APPROVED MINUTES

March 17, 2022 Standards Committee Meeting

RE: Minutes from the March 17, 2022 Standards Committee Meeting

INDIANA DEPARTMENT OF TRANSPORTATION	
TERMINAL JOINT, TYPE PCCP	
SEPTEMBER 2020	
STANDARD DRAWING NO. E 503-BATJ-02	
	 03/10/20 DESIGN STANDARDS ENGINEER DATE
	 04/02/20 CHIEF ENGINEER DATE

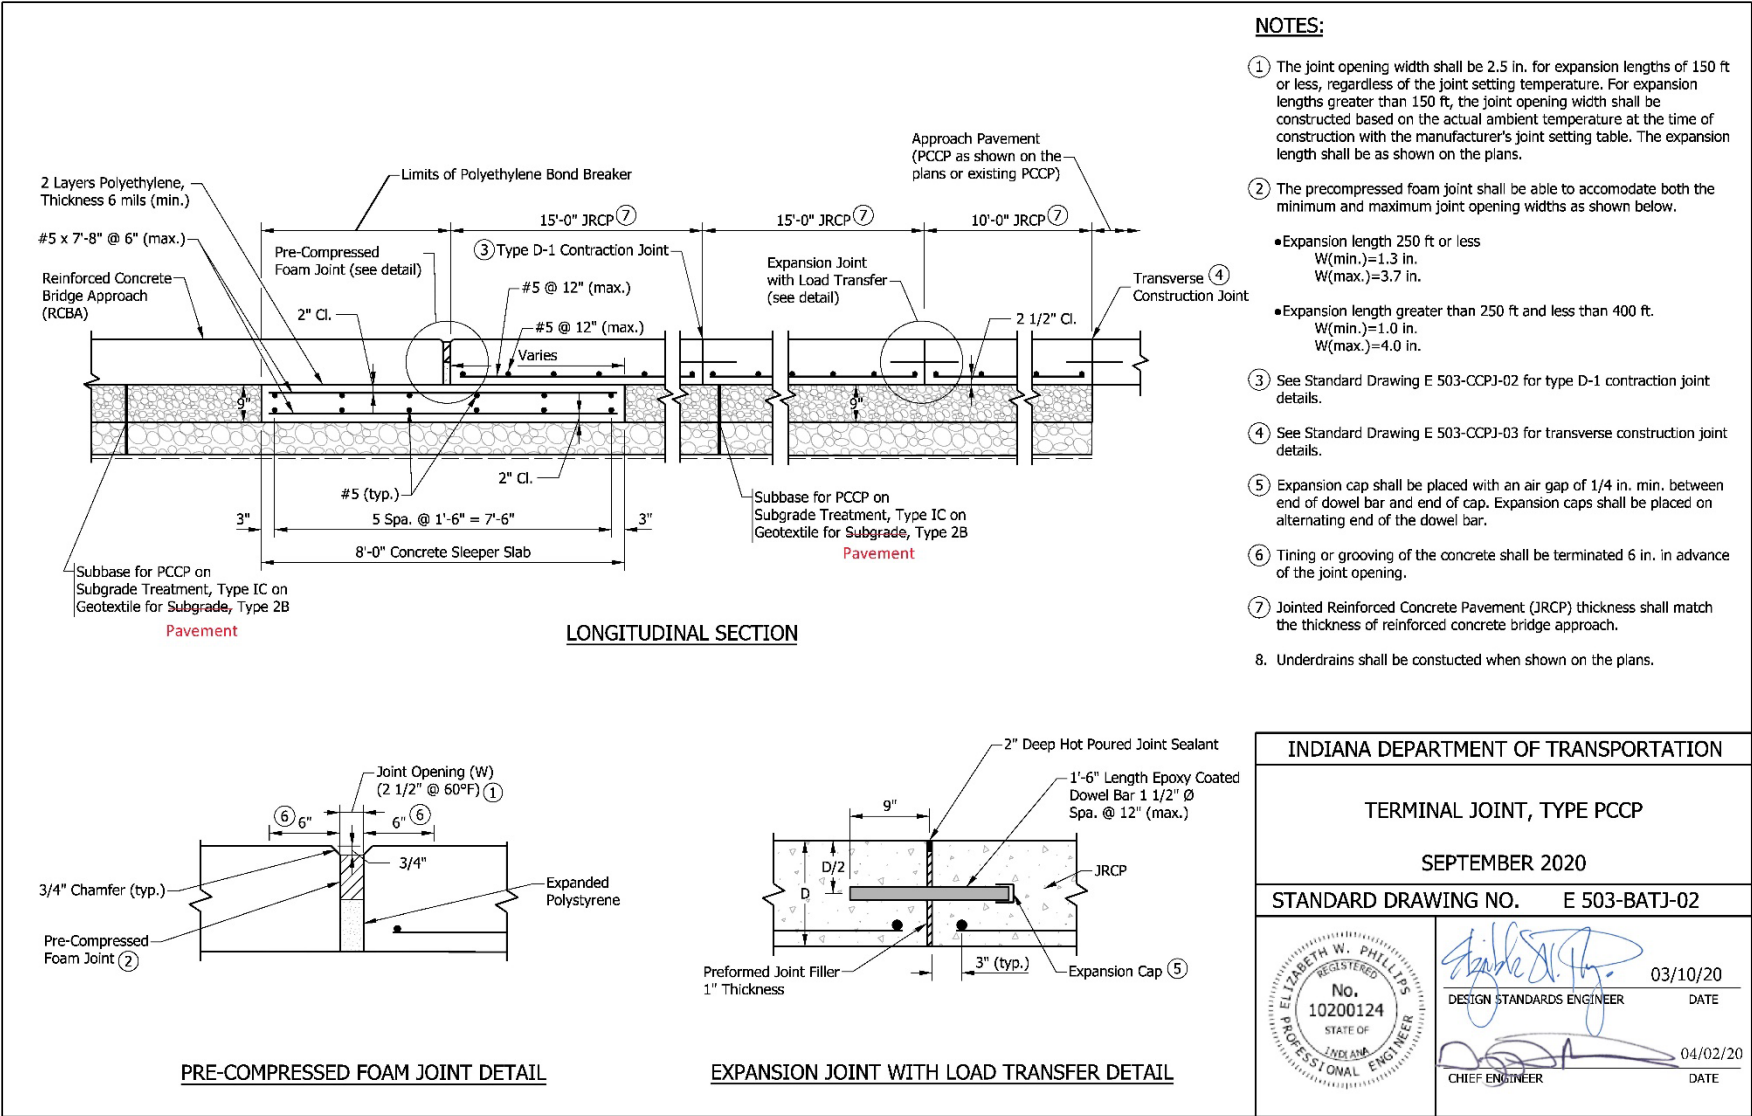
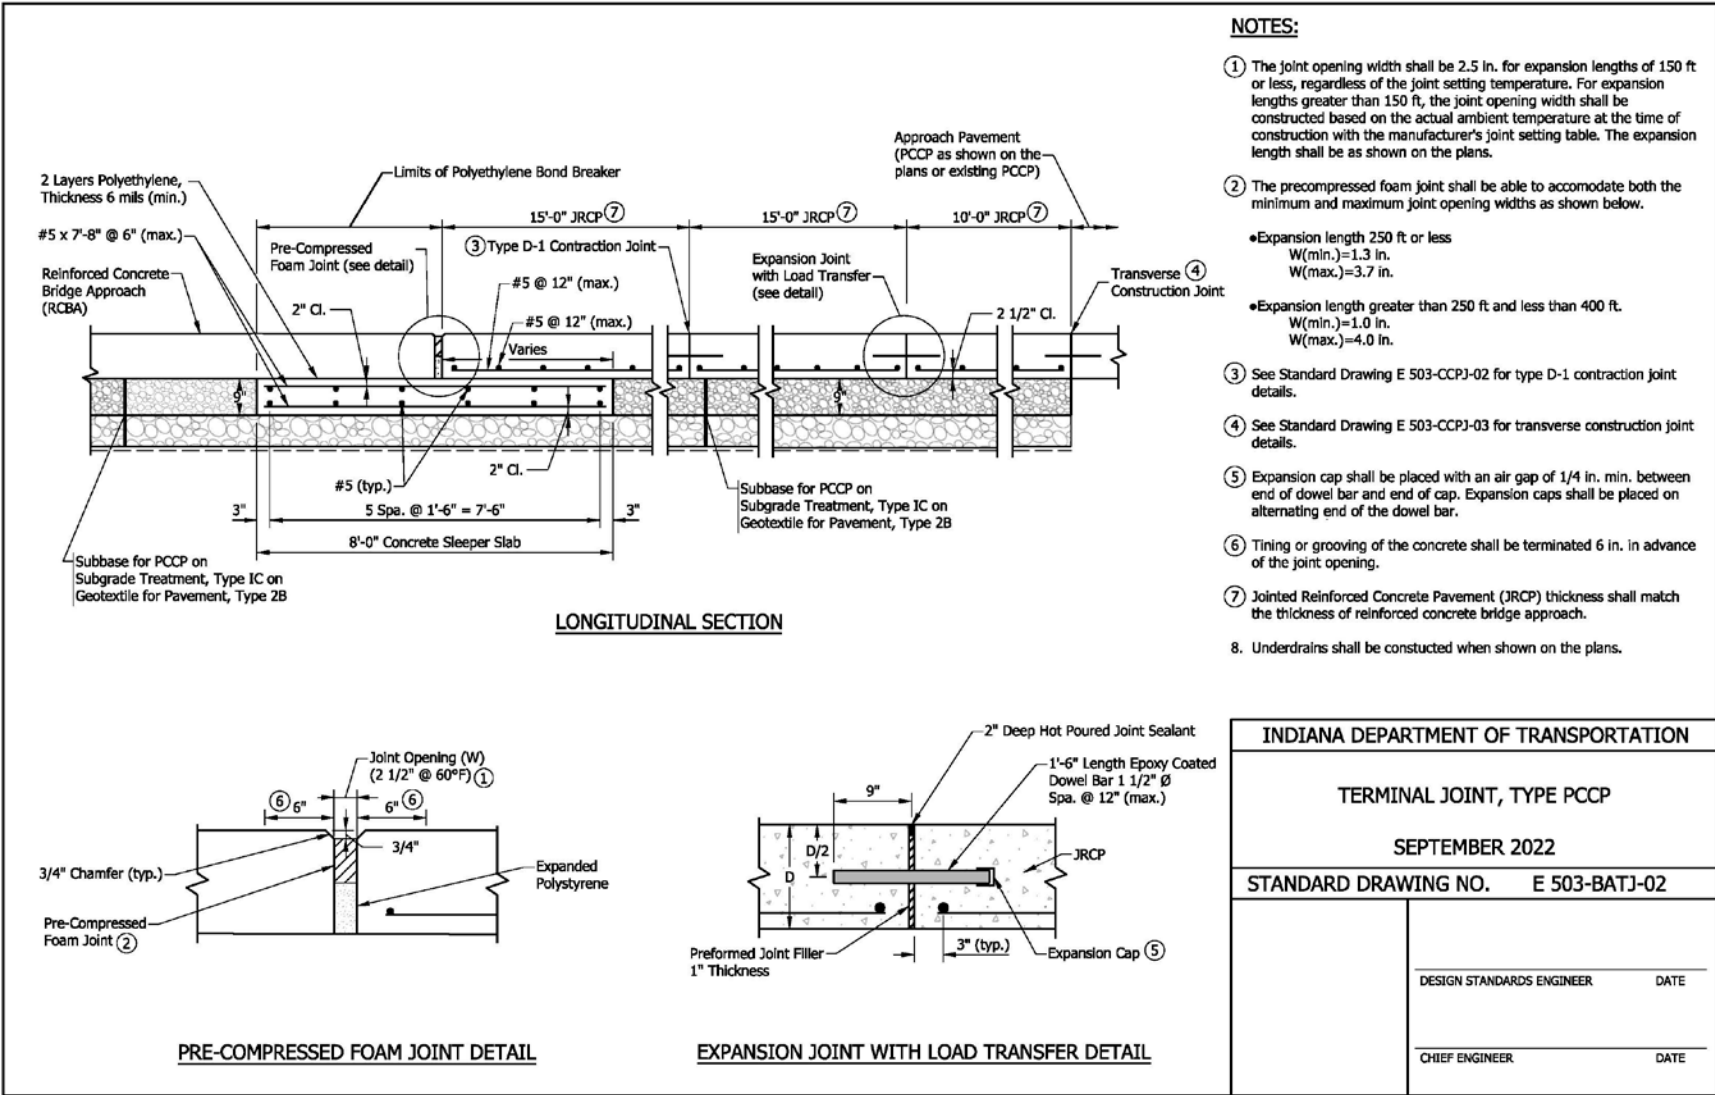
PROPOSED SOLUTION: Revise Standard Drawings E 609-RCBA-04, E 503-BATJ-02 and E 503-BATJ-03

Mr. Orton proposed to revise Standard Drawings E 609-RCBA-04, E 503-BATJ-02 and E 503-BATJ-03, as shown.
